REVISED STAFF REPORT AND RECOMMENDATION
TO THE LANDMARKS COMMISSION

CASE FILE: LU 16-153002 HRM AD
PC # 15-247619
Pearl East Building
REVIEW BY: Landmarks Commission
WHEN: February 27, 2017 @ 1:30pm
WHERE: 1900 SW Fourth Ave., Room 2500A
Portland, OR 97201

3. TYPICAL WINDOW HEAD (a) AND SILL (b)

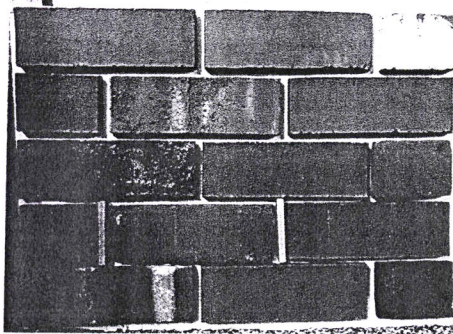
Findings: The two street-facing walls of the building include walls of mostly red brick divided into three horizontal sections divided by two string courses. The middle sections of these wall planes are punctuated by windows which are grouped with a two-tiered inset. The first step in the inset punches back from the building plane 3 5/8" inches. The insets then step back another inch before the beginning of the window (see figure from Exhibit C-15). The middle section includes windows that are grouped in threes like many of the buildings in the district including the historic building directly across 13th Avenue from the site. The ground floor windows are storefront-style windows with transoms which are inspired by but are not exact replicas of the building across the street. The pedestrian zone of the Glisan Street elevation is mostly board-formed concrete resulting in a need to modify the ground floor window standard which is discussed further below. This design is driven by the need to elevate the first floor on 13th Avenue to allow for the elevated loading dock feature on this façade and the desire to maintain the tri-partite design in order to be consistent with the character defining features of many of the buildings in the 13th Avenue Historic District. Project renderings indicate that the window returns will be brick but this is not detailed in the above window section.

Because the drawing above does not clearly indicate the material of the return staff suggests the following condition of approval:

- Window sill returns shall be clad in brick as indicated in the project renderings.

Therefore with the condition approval that window sill returns shall be clad in brick as in the project rendering this guideline is met.

Brick sample for Pearl East Building (left) with brick conditions at historic Fisk Building, Oregon Transfer Building, Modern Confectionary Lofts, Simon Building and The Gadsby Building depicted from left to right on the next page (From exhibit G-5)

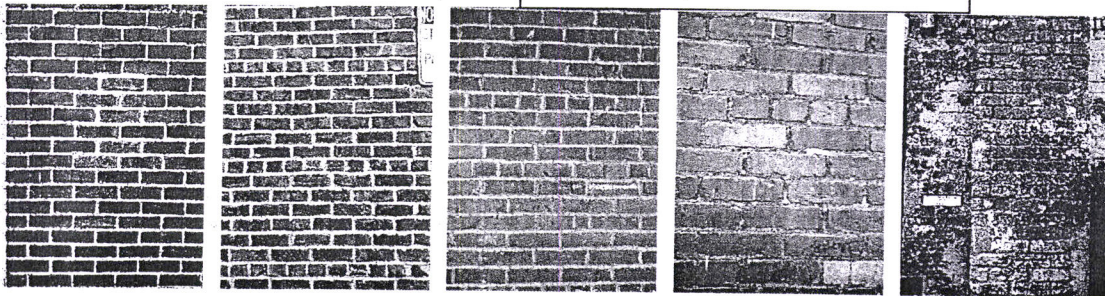
The two street-facing elevations of the building are clad in red brick on a board form concrete plinth. This brick over concrete condition is common in the district's tri-partite brick warehouse buildings like the Chown Pella Lofts and the Simon Building in the District. While concrete with visible boardformed

expression is not a common feature in the district, it presents an opportunity for the proposed building to mildly differentiate itself from the contributing resources in the district while still maintaining their general form and materials. The brick proposed for the building is a 7" by 2" red brick that with 5/16" joints in grayish brown. This is in keeping with the District's character. However, the sample provided to staff includes clinker bricks and faux-aged and distressed brick. It is unclear how prevalent the clinker and distressed brick will be in the building or how they might create patterns when utilized across the 6-story face of the building. This would create a distraction from authentically-aged contributing resources in the district.

Therefore Staff suggests the following condition of approval:

- No more than 15% of the bricks used to clad the building will be dark clinker brick or show signs of paint, efflorescence or other forms of distress.
- All pre-distressed decorative brick will be distributed evenly across the building.
